<b>SUNDRY NOTICES AND REPORTS ON WELLS</b> (DO NOT USE THIS FORM FOR PROPOSALS TO DRILL OR DEEPEN OR PLUG BACK TO A DIFFERENT RESERVIOR. USE "APPLICATION FOR PERMIT" (FORM C-101) FOR SUCH PROPOSALS.)		WELL API NO. <b>30.025.39562</b>

2. Name of Operator <b>Apache Corporation</b>		6. State Oil & Gas Lease No. <b>AO-3071-0000</b>
3. Address of Operator <b>303 Veterans Airpark Lane, Ste. 3000, Midland, TX 79705</b>		7. Lease Name or Unit Agreement Name <b>Hansen State</b>

4. Well Location Unit Letter <b>A</b> : <b>990</b> feet from the <b>N</b> line and <b>990</b> feet from the <b>E</b> line Section <b>16</b> Township <b>20S</b> Range <b>37E</b> NMPM County <b>LEA</b>		8. Well Number <b>#011</b>

**Apache Corporation proposes to P&A the above mentioned well by the attached procedure. A closed loop system will be used for all fluids from this wellbore and disposed of required by OCD Rule 19.15.17.14 NMAC.**

WELL BORE INFO.

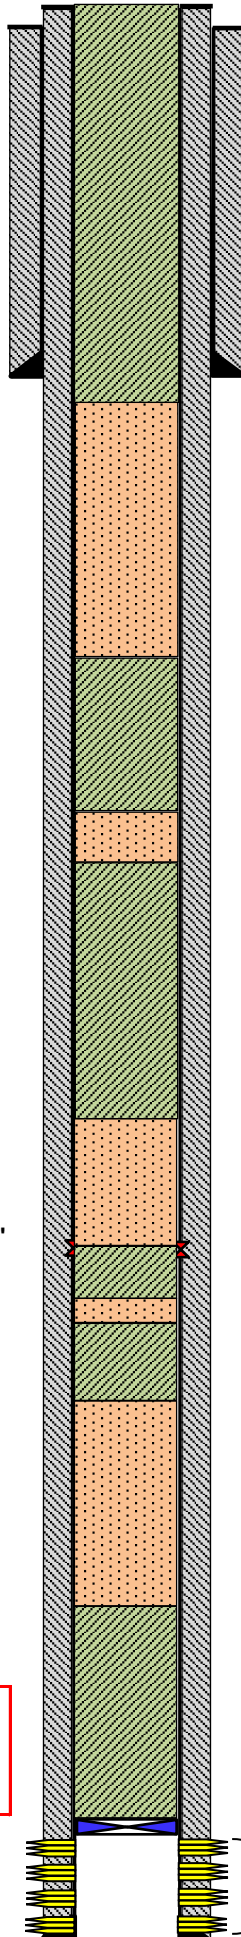
LPC Area Below ground marker send pics before backfilling hole

OCD Reviewer	Condition
kfortner	See attached conditions of approval LPC Area Below ground marker
